## COUNCIL SUPPLEMENTARY REPORT

<b>Panel Reference</b>	2017SNH012
<b>Application Number</b>	LDA2016/0395
<b>LGA</b>	City of Ryde
<b>Proposed Development</b>	Construction of a mixed use development
<b>Street Address</b>	25-27 Epping Road, Macquarie Park (Lachlan's Line)
<b>Applicant/Owner</b>	Greenland (Sydney) Lachlan's Line Macquarie Park Development Pty Ltd
<b>Date of Lodgement</b>	1 July 2016
<b>Recommendation</b>	Approval
<b>List of all documents submitted with this report for the Panel's consideration</b>	<p><u>Appendix A</u> Assessment Report</p> <p><u>Appendix B</u> Draft Conditions</p> <p><u>Appendix C</u> Covering letter from Urbis and attachments:</p> <ul style="list-style-type: none"> <li>• Attachment A: 'Summary Expert Opinion – Solar Access';</li> <li>• Attachment B: 'SEPP 65/ADG Solar Access Plans';</li> <li>• Attachment C: 'Gross Floor Area Plans'; and</li> <li>• Attachment D: Amended plan 'DA02.100 (Revision K) – Key Plan Ground Level'.</li> </ul>

<b>Report prepared by</b>	Tony Collier – Acting Senior Coordinator Major Development
<b>Report date</b>	30 August 2017

**Figure 1 – Location of open space areas A, B & C (shown at 10.30am on 21 June)**

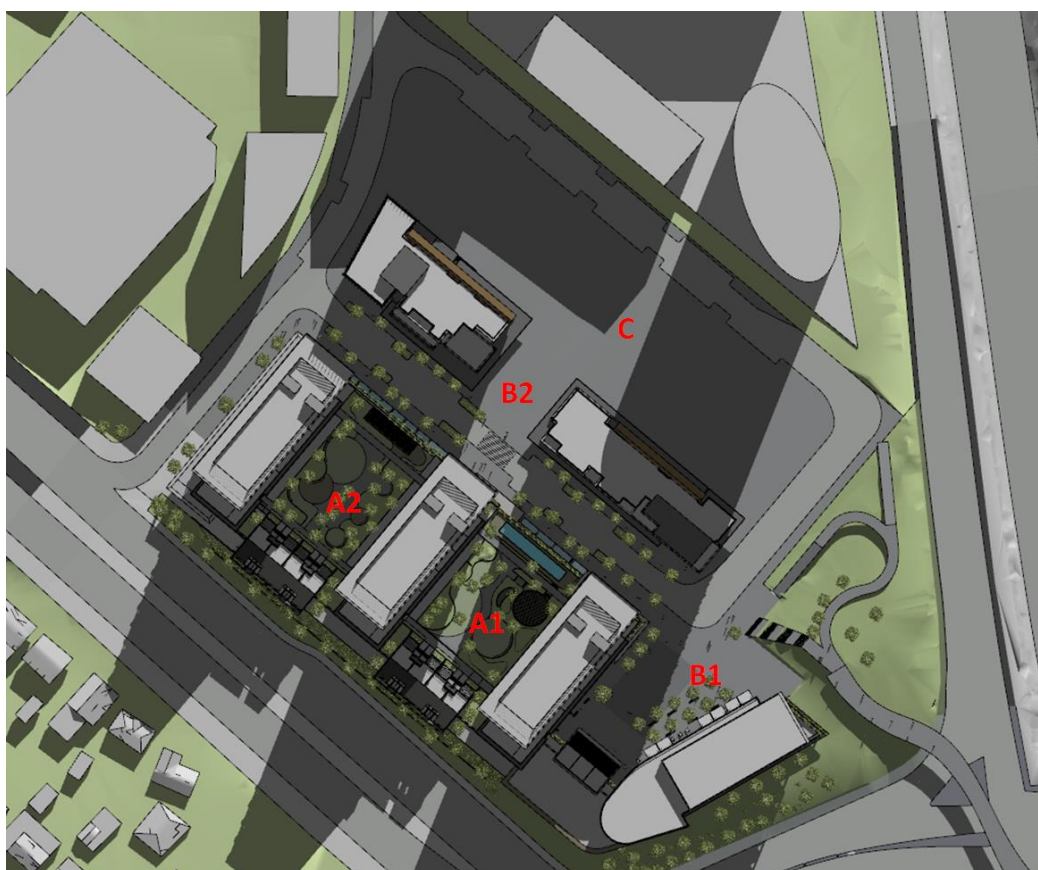
As noted earlier, Steve King has adopted a qualitative commentary for solar access to communal open space. In analysing solar access, Steve King identifies three areas:

- A. Conventional Communal Open Space (Being courtyards between Buildings L1, L2 and L3);
- B. Publicly Accessible Communal Open Space (Being the plaza between Buildings L3 and M and the space between Buildings J and K); and
- C. Public Open Space (Being the public park to the north-east of Lot 105).

Development Application	Steve King
Lot 104: Information not provided Lot 105: Information not provided	Conventional Communal Open Space: Max 15% at 11.30am Publicly Accessible Communal Open Space: 50% at 10.30am Public Open Space: 100% at 9am to 3pm

Development Application	Steve King
Lot 104: Information not provided Lot 105: Information not provided	Conventional Communal Open Space: 50% at 9am to 1pm Publicly Accessible Communal Open Space: Less than 50% Public Open Space: Similar to mid-winter

Solar access to communal open spaces was not detailed in the Development Application so no comparison can be made. However, it is noted that the calculated solar access identified in Steve King's report is quantitatively lower than that required by the Apartment Design Guide (ADG).

**Figure 2 – Amended Plan (Issue K to the right) deleting enclosed retail area adjacent to escalator.**

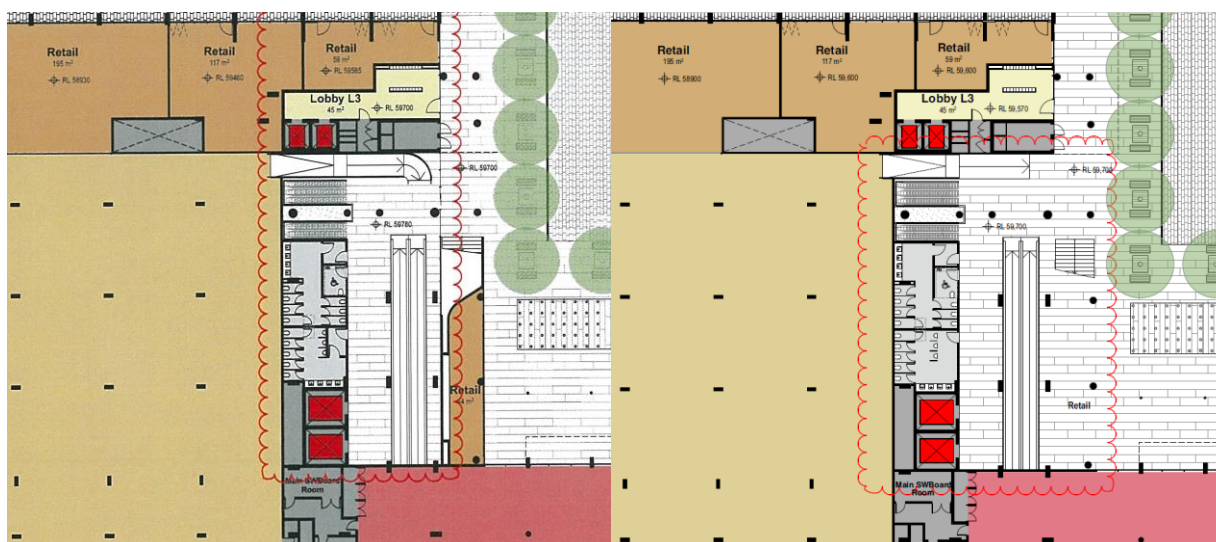
On reviewing the GFA for this exercise, the applicant amended floor plan for the Ground Level at Lot 104 (Lachlans Line).

The amendment involves the removal of the enclosed retail space adjacent to the escalator and minor reconfiguration of amenities facilities. This results in a more open floor plan which is supported by Council.

The changes are considered to result in a more open design which is supported by Council and Condition No. 1 has been amended to include the revised plans.
